Technical Bulletin

TSB 51215

P/N EB20J T3

Advance Adapters Casting #51-2703

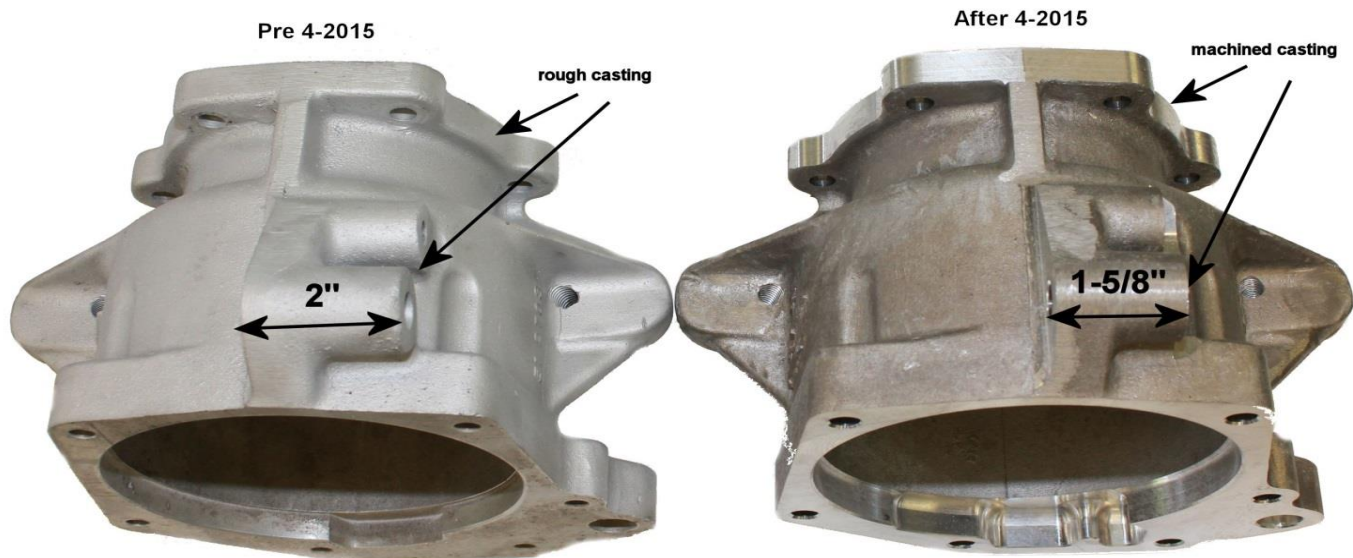
Due to changes made in production of Advance Adapters Casting # 51-2703, mounting JB Custom Fabrication's Type-3 and Type-4 Early Bronco stainless twin-stick shifters, are as follows:

Type- 3 (after 4-2015) replace washer between shifter and casting with aluminum spacer.

Type- 4 (after 4-2015) use longer (2- 1/2") shoulder bolt supplied with kit, and aluminum spacer between shifter and casting.
